Delaware State University
Third Floor HVAC Modifications
Contract Number: PC-2014-002 SCNHVACR

Addendum #2

DRAWING NO.
E-1

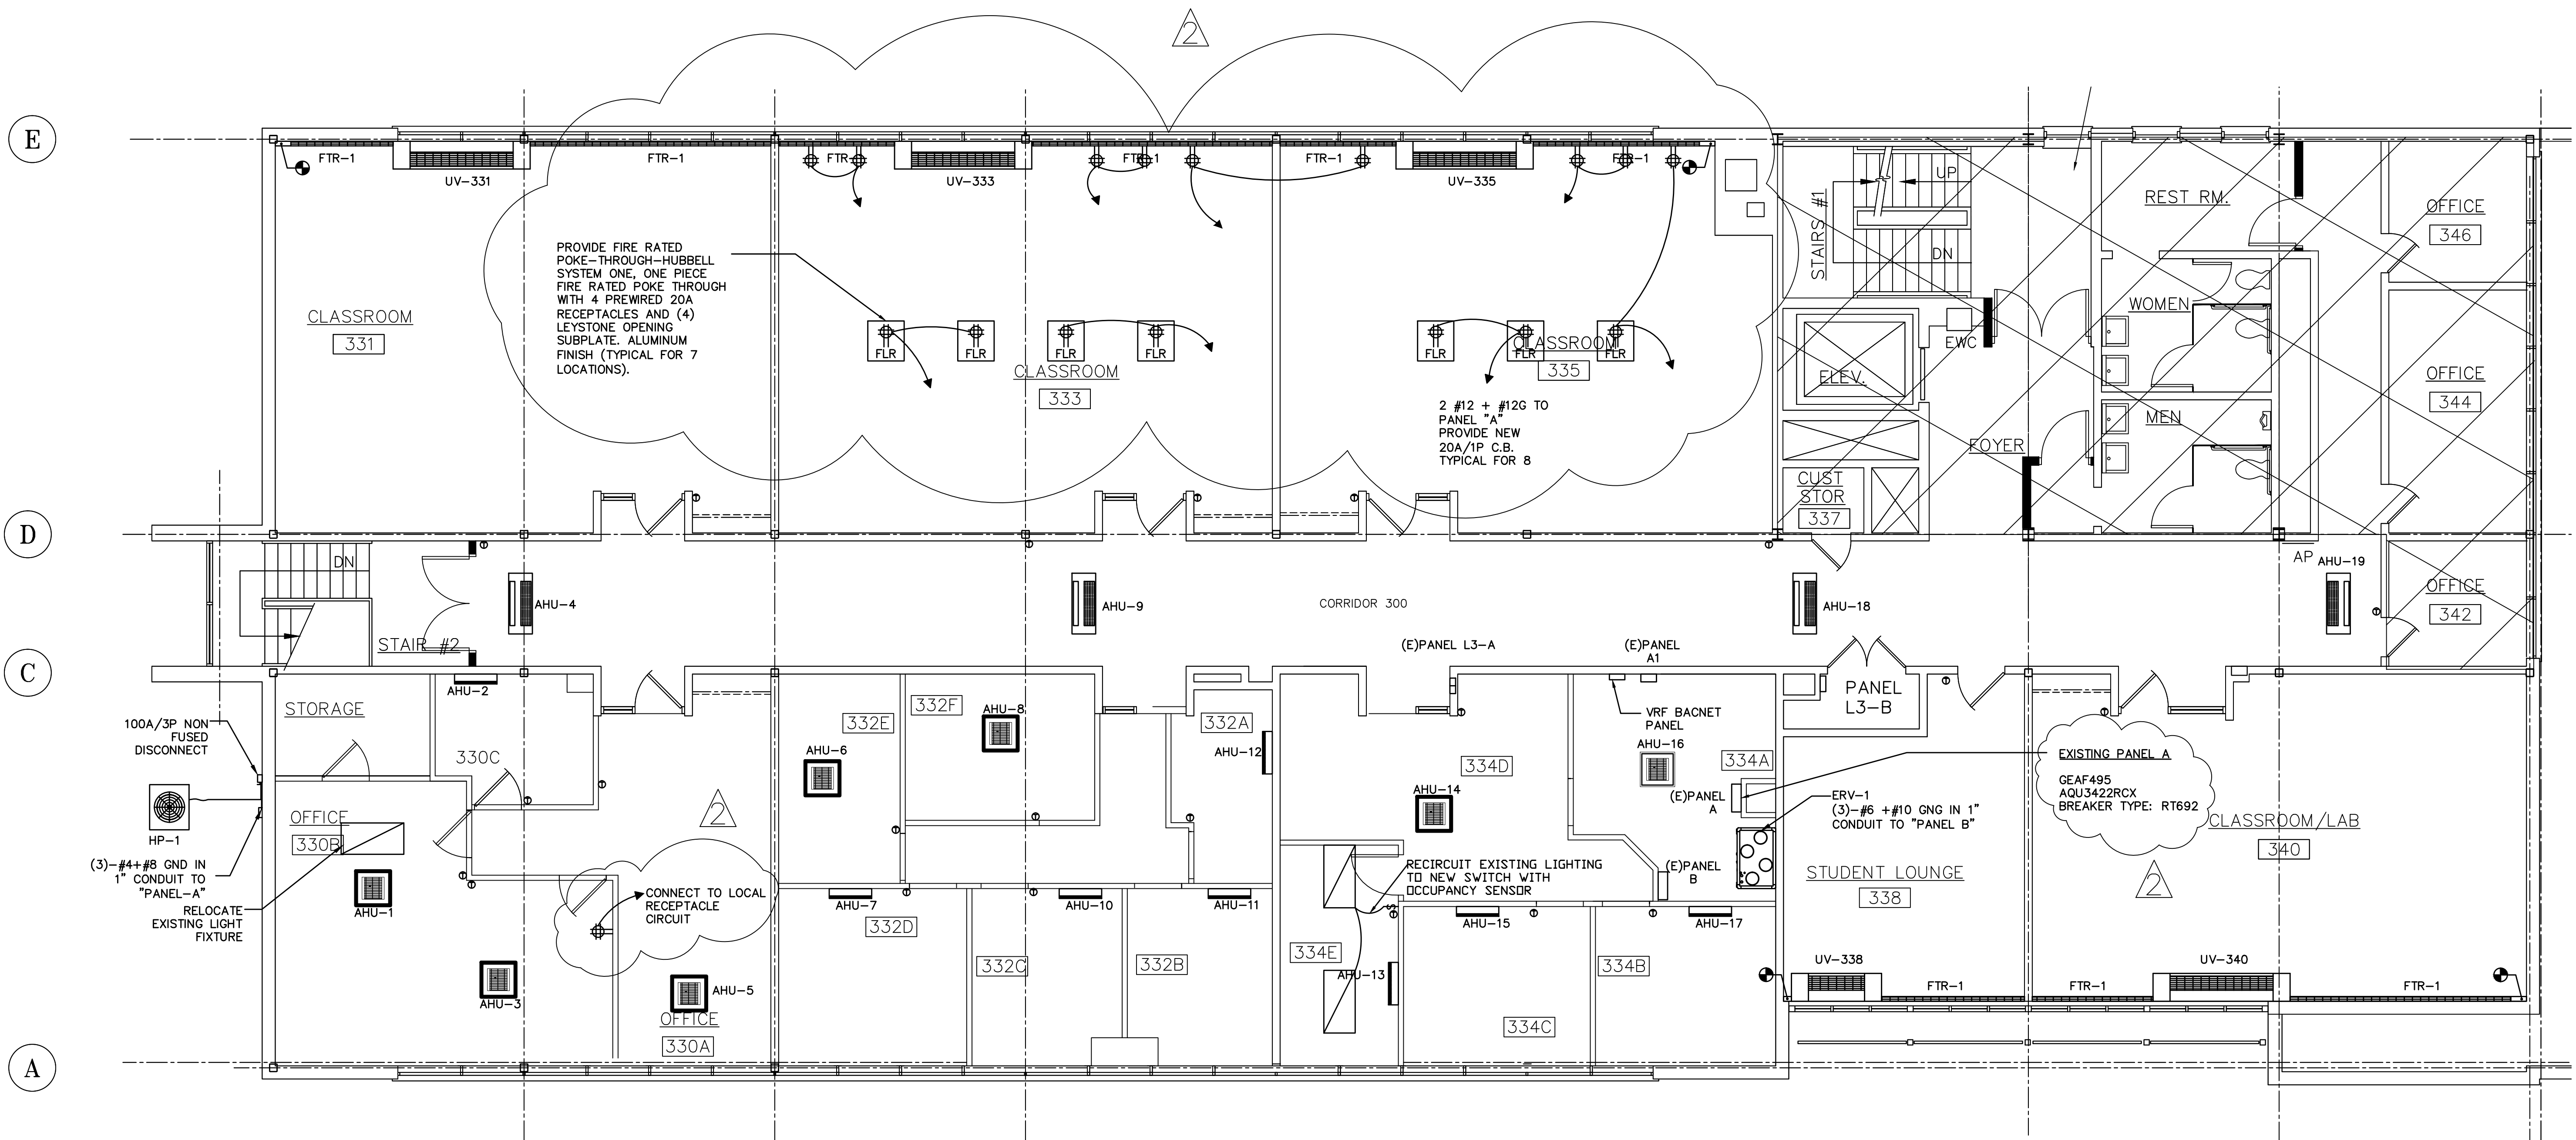
1. Attached is revised drawing E-1. Receptacles have been added in various locations indicated.
